*Final  
Environmental Impact Report*

# **CITRACADO PARKWAY EXTENSION PROJECT**

*City File # ER-2006-10  
SCH# 2007041061*

February 2012

**Figure 3.1-1**  
Existing and Proposed Land Use Designations

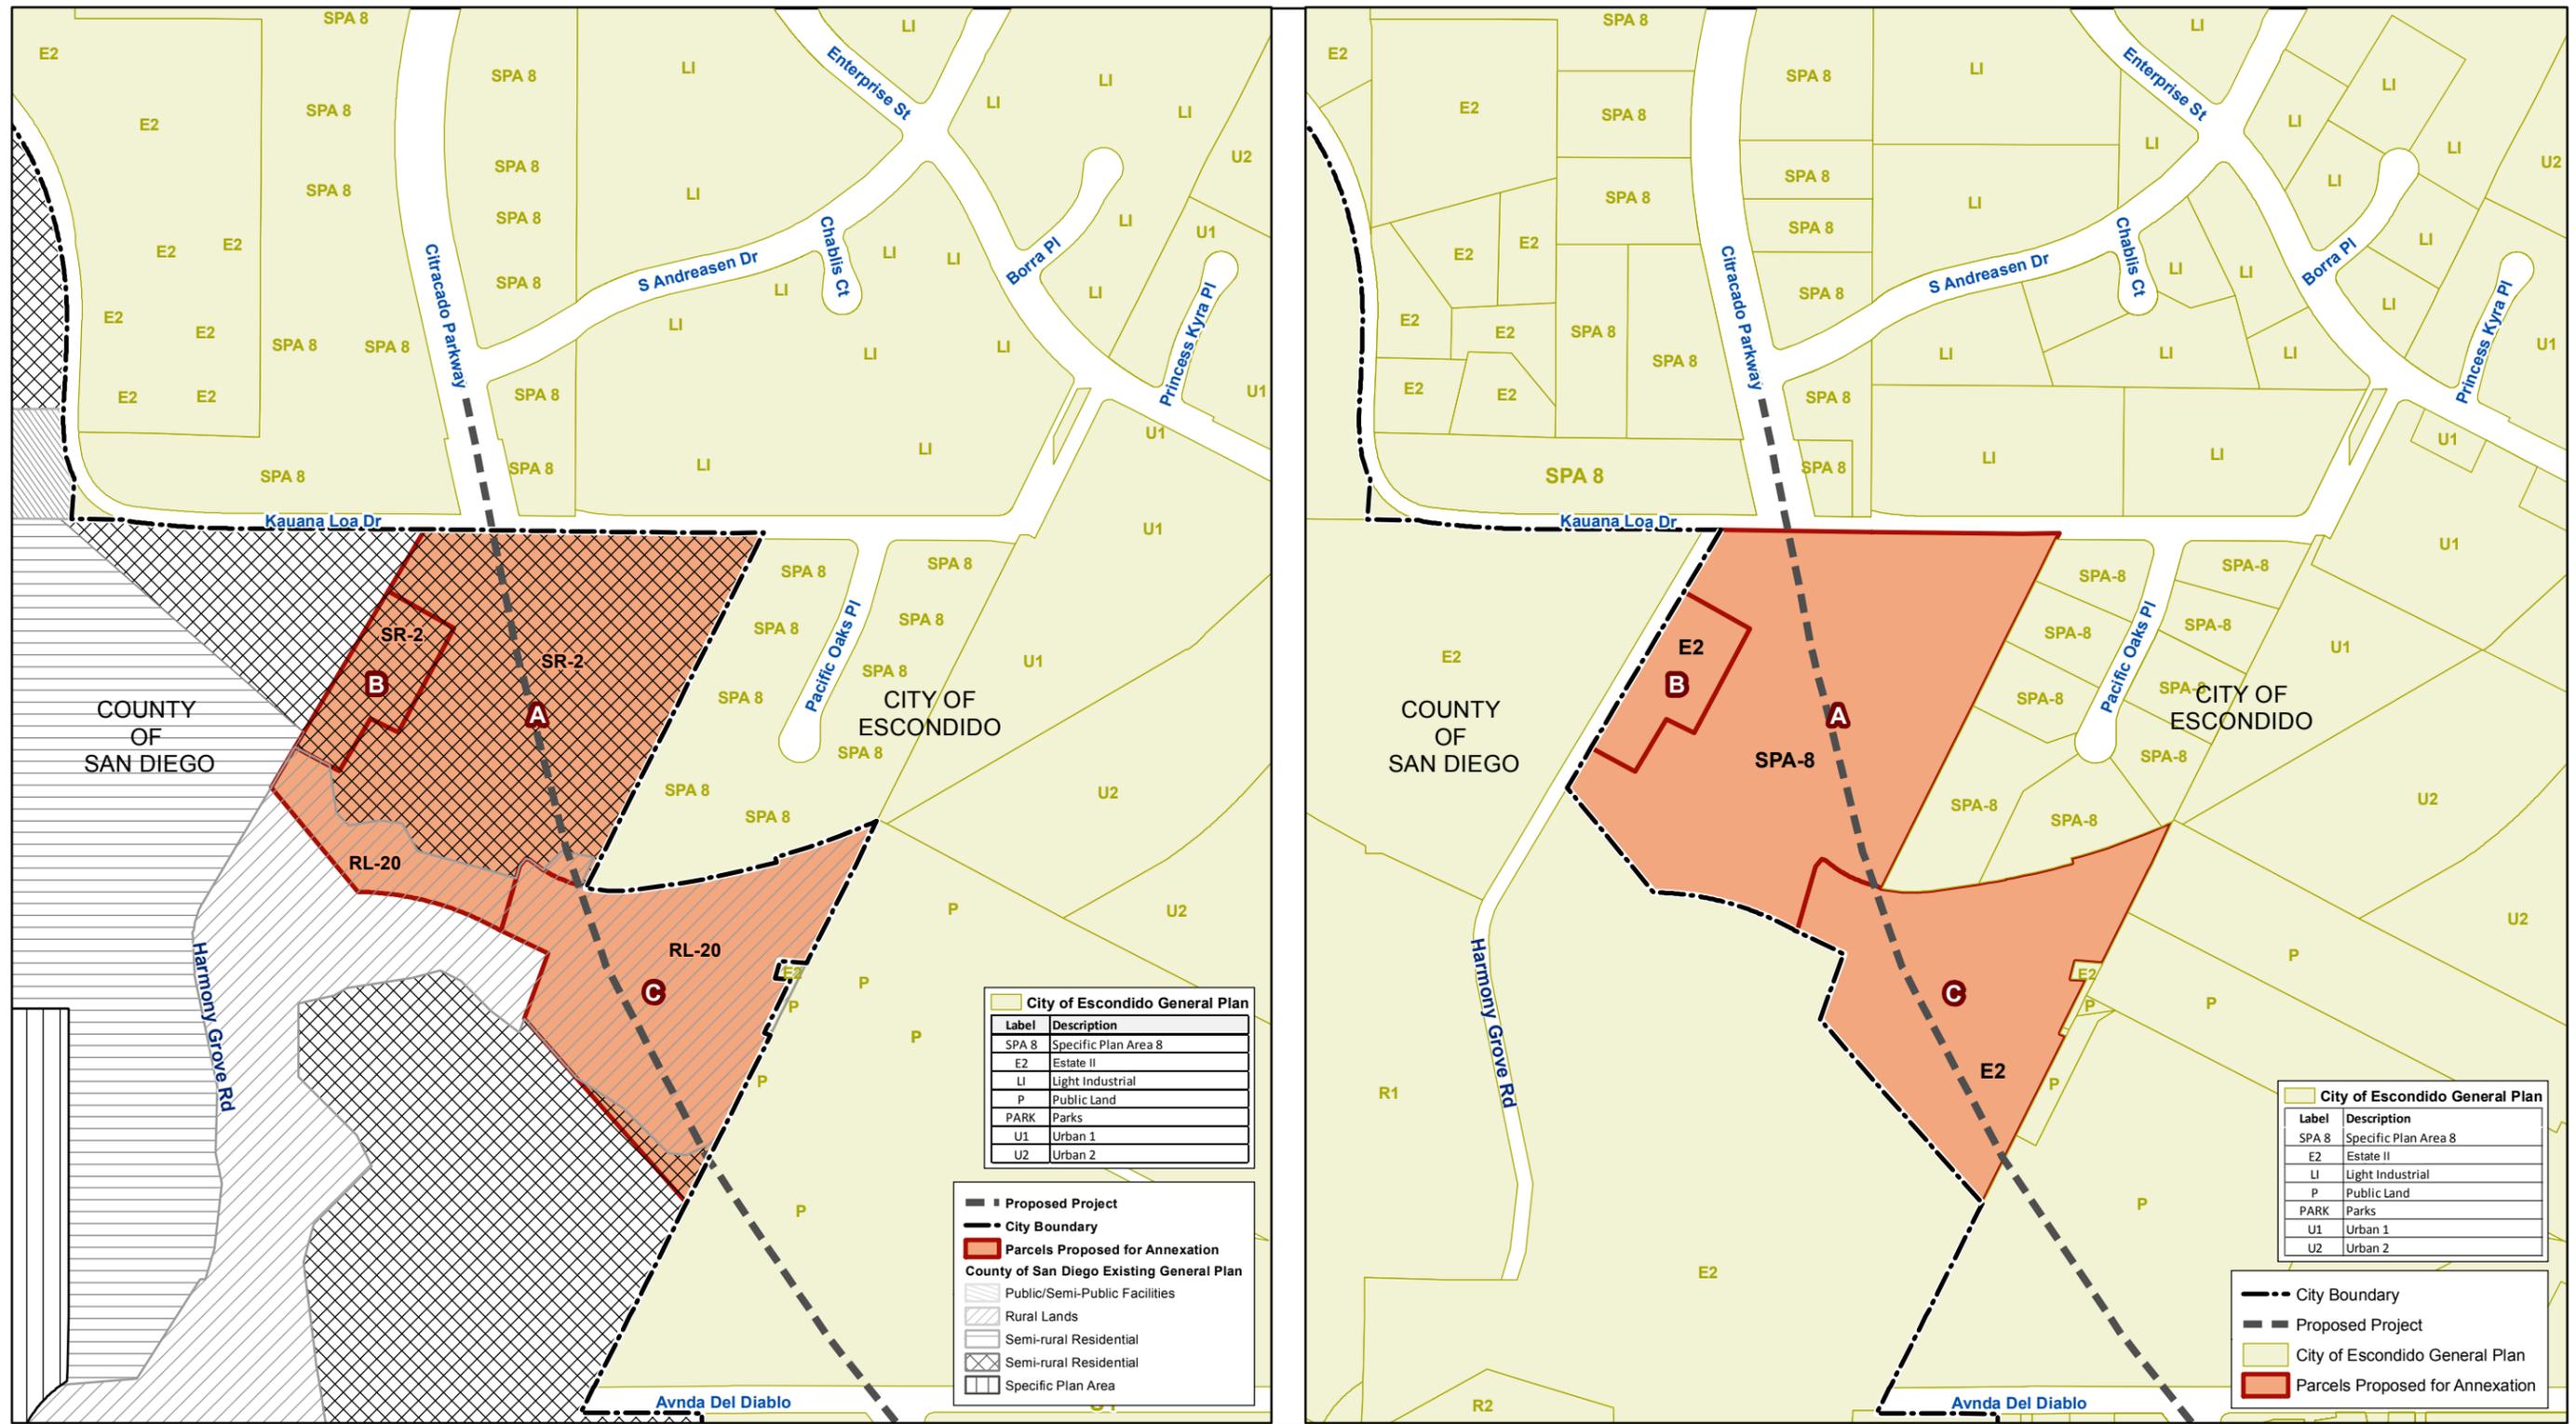
G-16 **Figure 3.1-1 Existing and Proposed Land Use Designation**  
 This figure should be updated to reflect the County-approved General Plan (2011).

G-16 Figure 3.1-1 has been updated to reflect the County-approved 2011 General Plan.

**Figure 3.4-2**  
**Vegetation Map**

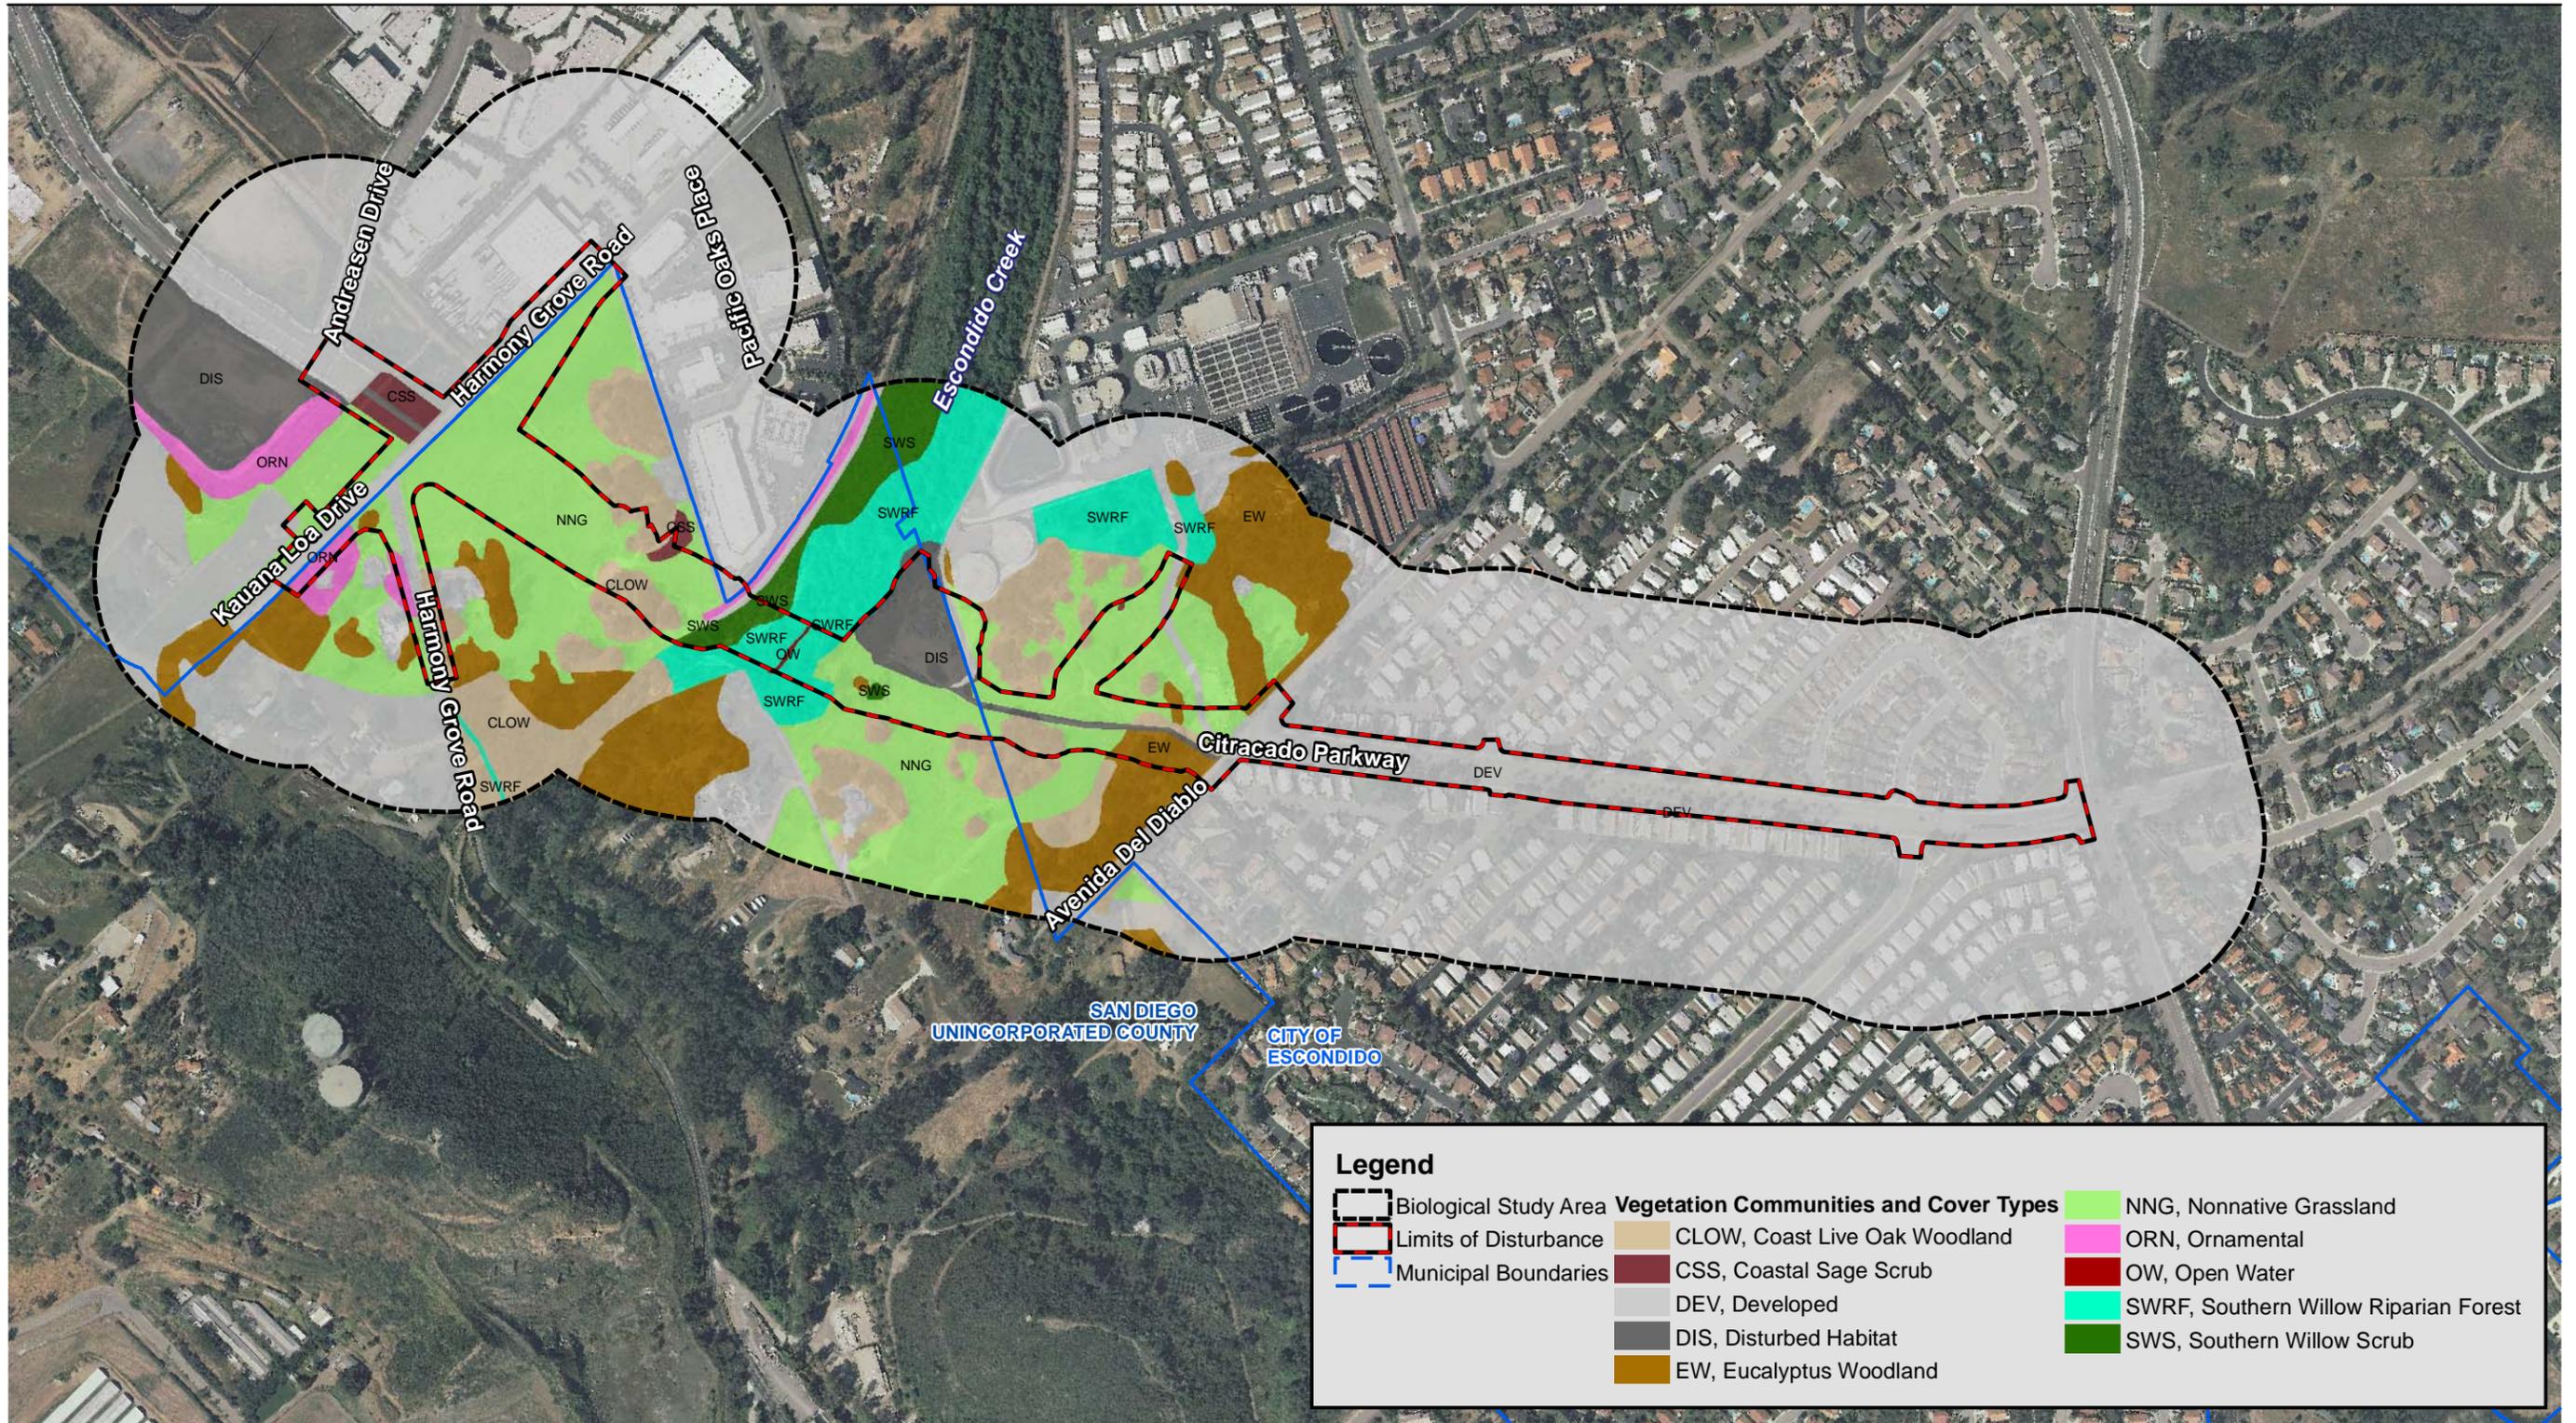
**Figure 3.4-2**

**G-26** | Figure 3.4-2 has been updated to correctly label Harmony Grove Road and Kauana Loa Drive.

**Figure 3.4-5**  
**Sensitive Wildlife Species**

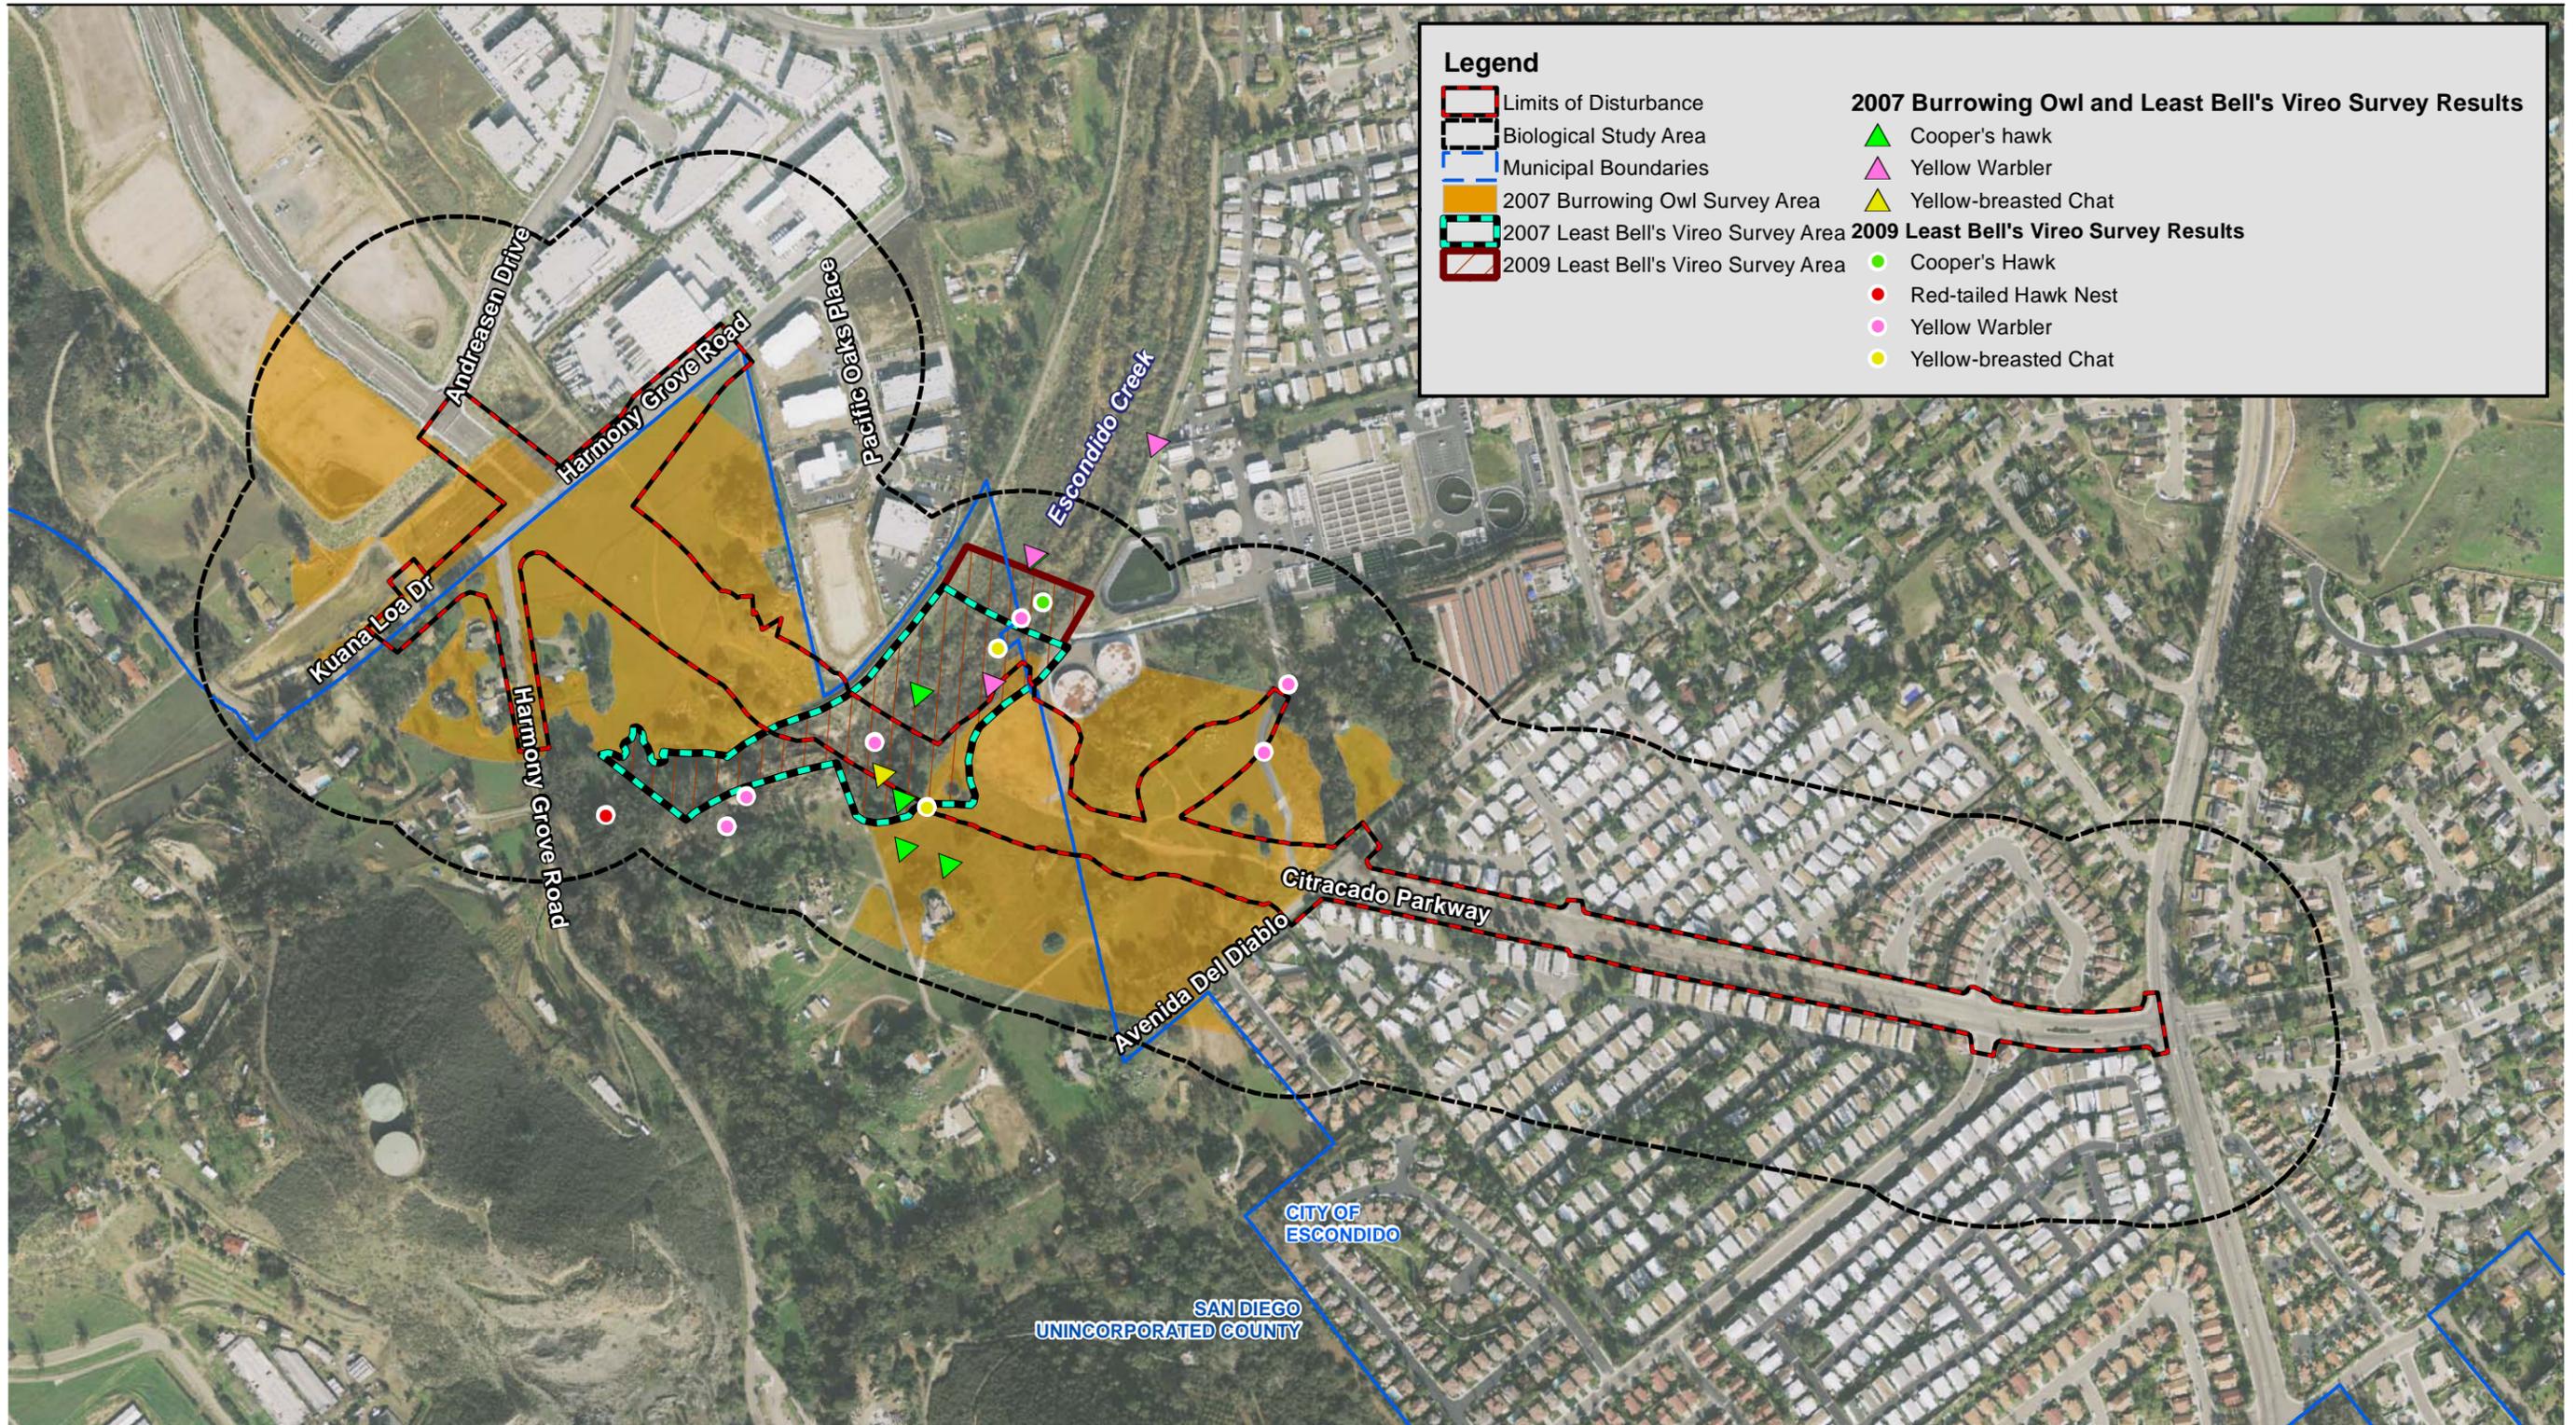
**Figure 3.4-5**

**G-27** | Figure 3.4-5 has been updated to correctly label Harmony Grove and Kauana Loa roads.
